[Docket No. FAA–2016–9418; Product Identifier 2016–NE–23–AD; Amendment 39–19167; AD 2018–02–14]

Airworthiness Directives; Honeywell International Inc. Turboprop and Turboshift Engines

ACTION: Final rule.

Figure 1 to Paragraph (h) of this AD. Combustion Chamber Case Assembly Without the One-Piece Bleed Pad with P3 Boss

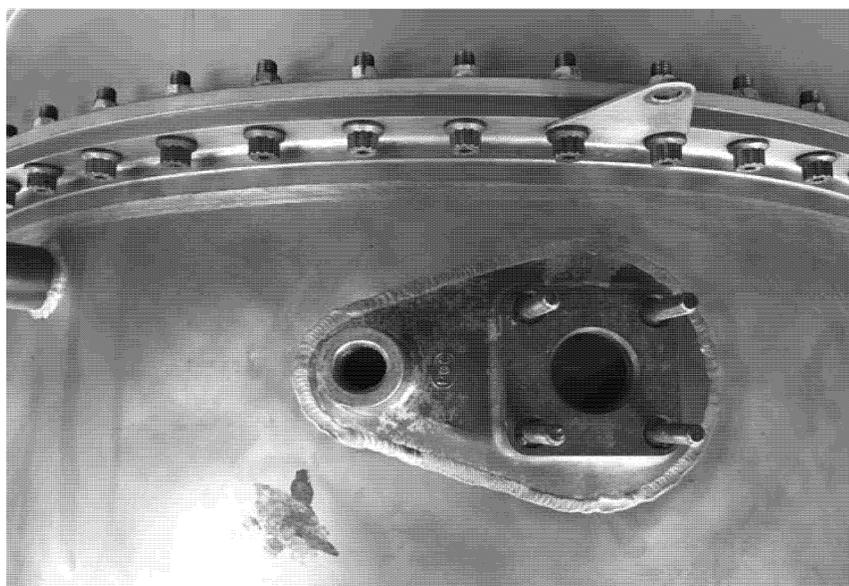
Perimeter Aviation LP (Perimeter) requested we add information to this AD regarding the number of failures of combustion chamber assemblies with or without the one-piece bleed pad. Perimeter requested further information on how these failures relate to the P/N 3101668-12 combustion chamber assembly.

TPE331 model engines modified by STC SE383CH may be defined as the “Super 1” and “Super 2” for the compressor modification of the TPE331–1 and the TPE331–2, –2U, and –2UA engines, respectively. Figures 1 and 2 to paragraph (h) of this AD illustrate the appearance of combustion chamber case assembly, P/N

893973-5, without and with, respectively, the one-piece bleed pad with the P3 boss.

We agree. We note that five of the six combustion chamber case assemblies that ruptured were assemblies without the one-piece bleed pad. P/N 3101668-x has the one-piece bleed pad with P3 boss, which demonstrated significantly reduced cracking between the P3 and bleed boss; therefore, this combustion chamber case assembly is not affected by this AD. No further changes are needed. We did not change this AD.

After the effective date of this AD, do not install a combustion chamber case assembly,

P/N 869728-1, 869728-3, or 893973-5, in TPE331-3U, -3UW, -5, -5A, -5AB, -5B, -6, and -6A engines or in TPE331-1, -2, and -2UA engines modified by National Flight

Services, Inc., STC SE383CH, unless the combustion chamber case assembly has a one-piece bleed pad with P3 boss.
